**Medway Planning & Economic Development Board
Meeting**

**Mockingbird Lane Multifamily
Development – 56 Summer Street
Revised Site Plan
Informal, Pre-application Discussion**

- Letter dated 11-23-21 from Robert G. Murphy, the proponent's environmental consultant, relative to a revised site plan for 56 Summer Street
- Revised site plan dated 11-12-21 prepared by Robert G. Murphy & Associates based on feedback from the first informal discussion held with the PEDB on 10-12-21.
- **Letter dated 12-13-21 from abutter Paul Yorkis**

SHEET 3 OF 4

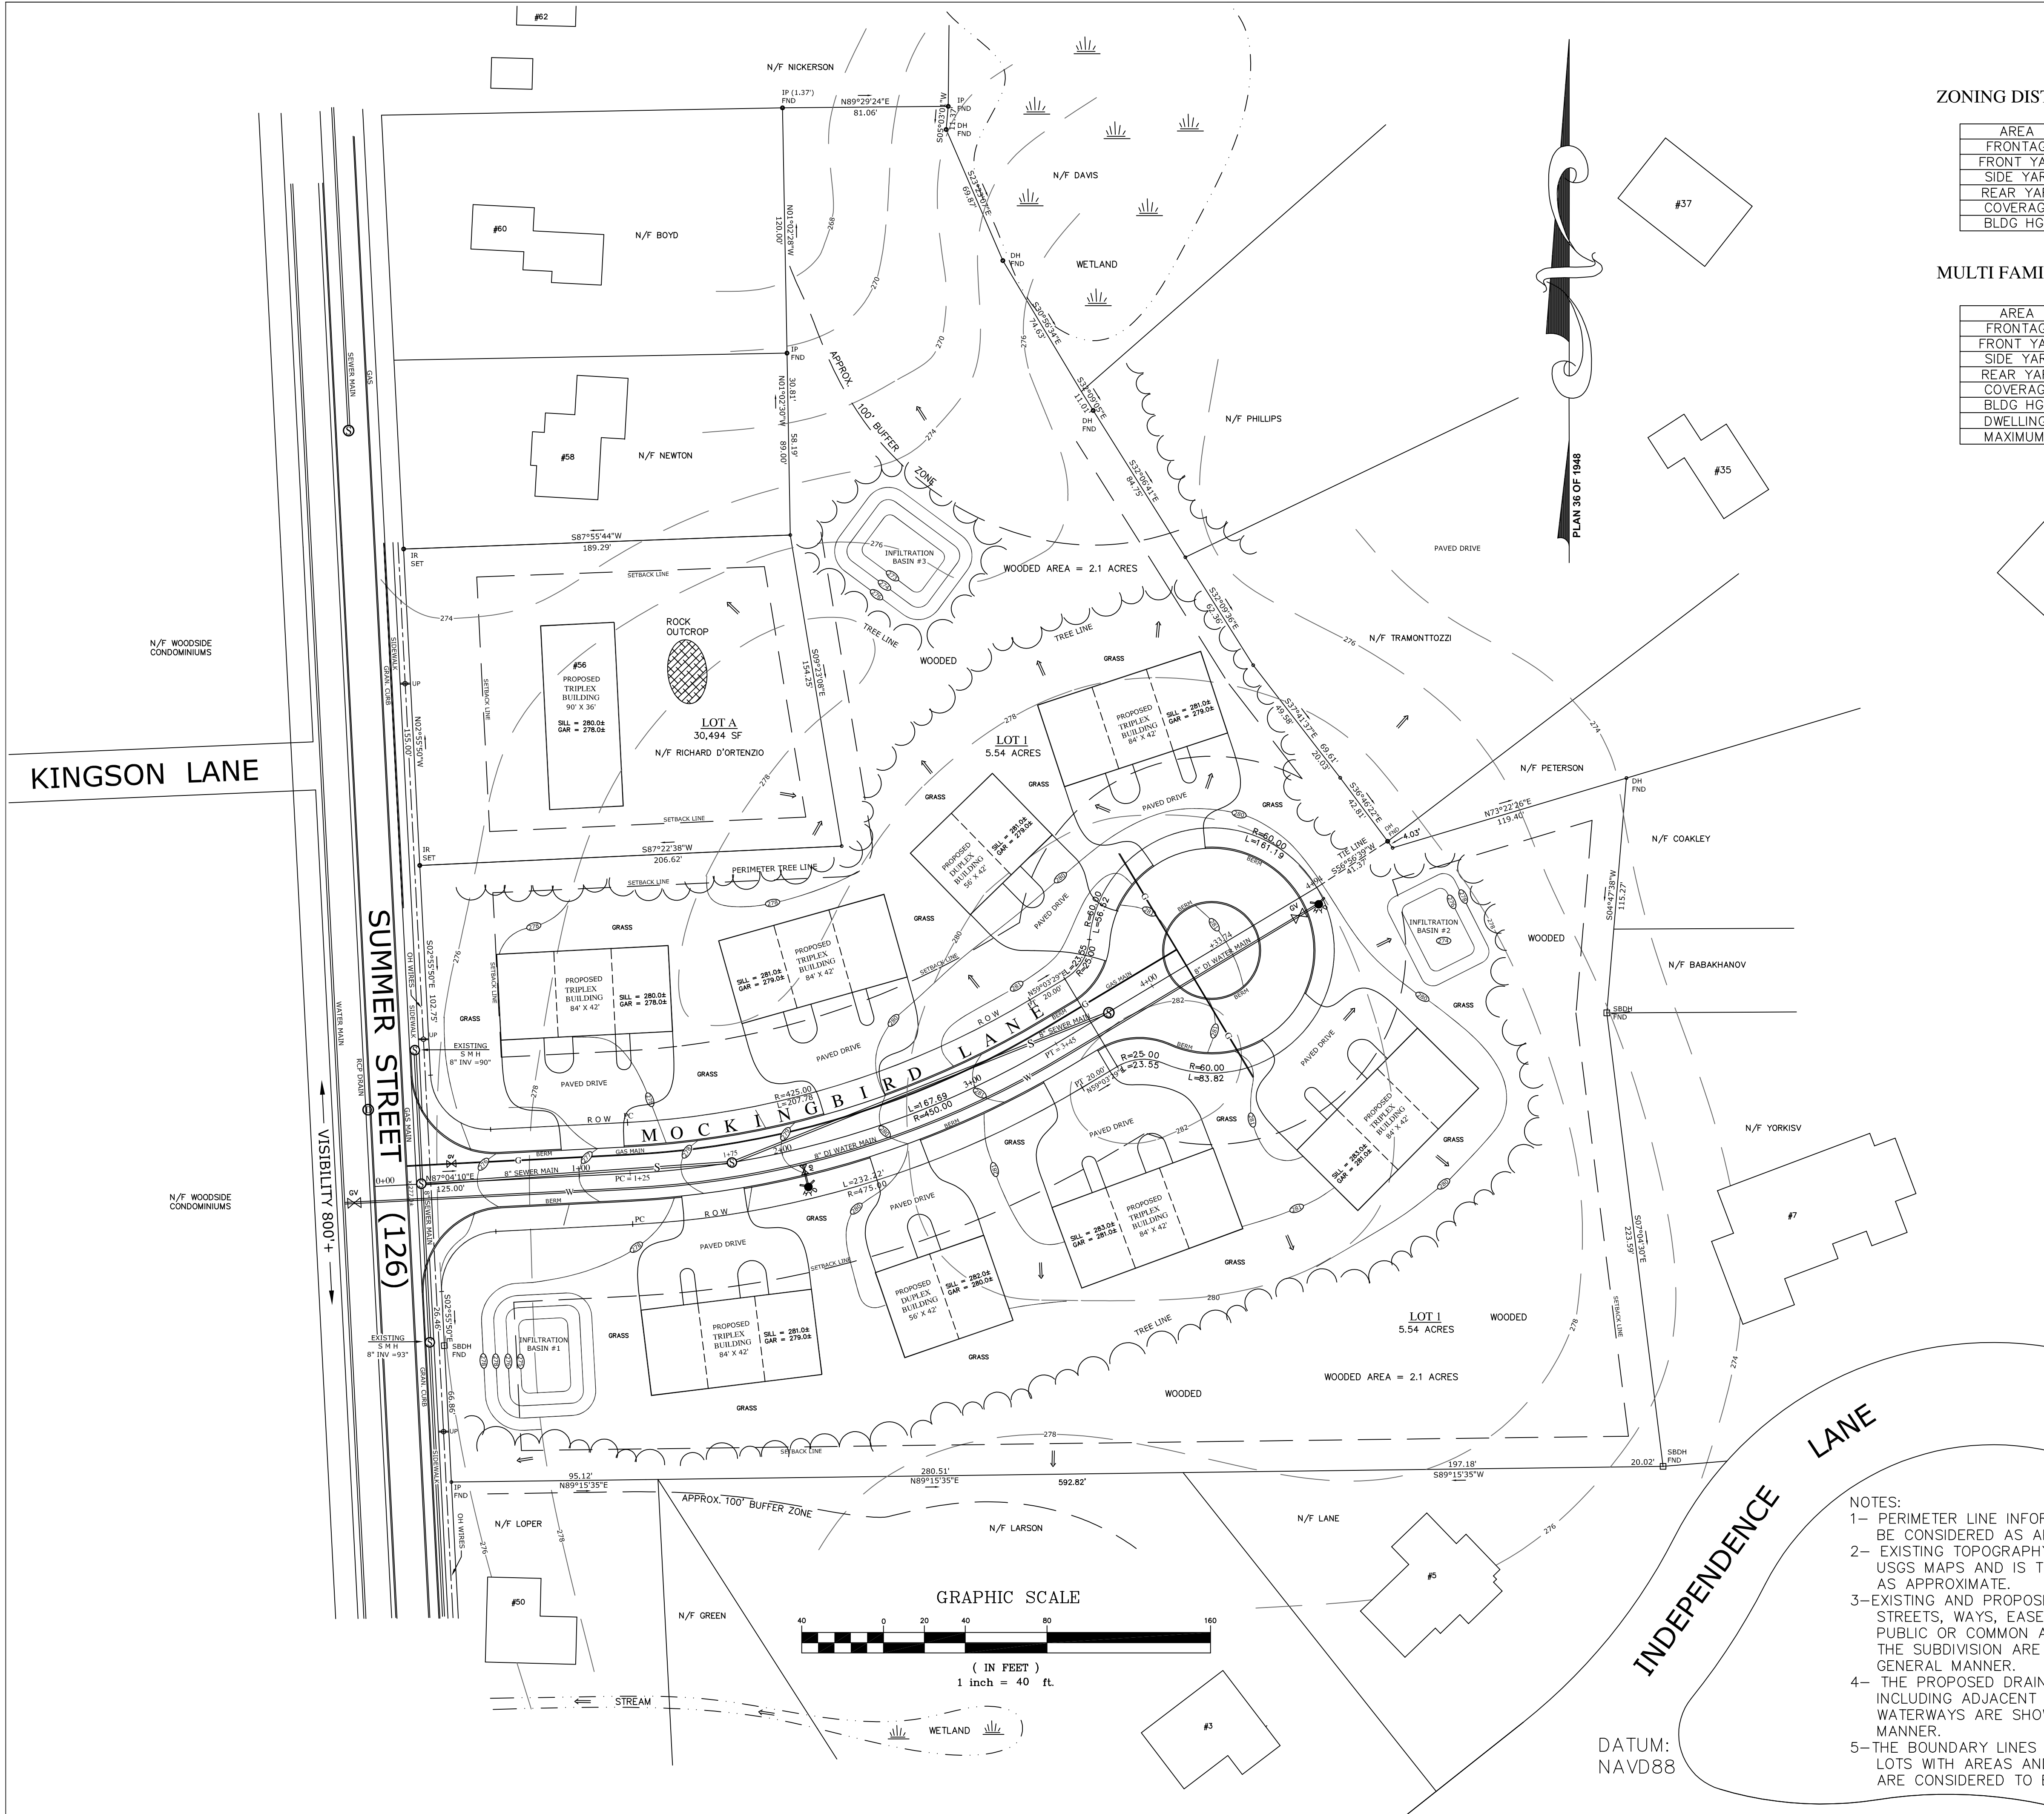
5. On sheet 3 of 4 of the plans the elevation line that goes through the basement of my home at 7 Independence Lane, which has a walkout basement, is 274 which is the same elevation proposed for the bottom of infiltration basin # 2. For the official record of the PEDB, since my wife and I have lived at 7 Independence Lane we have never had water in our basement and have never had standing water in our backyard.

6. On sheet 3 of 4 of the plans show infiltration basin # 3 in a wooded area. It is disingenuous to show the proposed basin surrounded by woods because trees will need to be removed to create the basin, to install the piping that will connect to the basin, and to provide a permanent access to the basin for maintenance purposes.
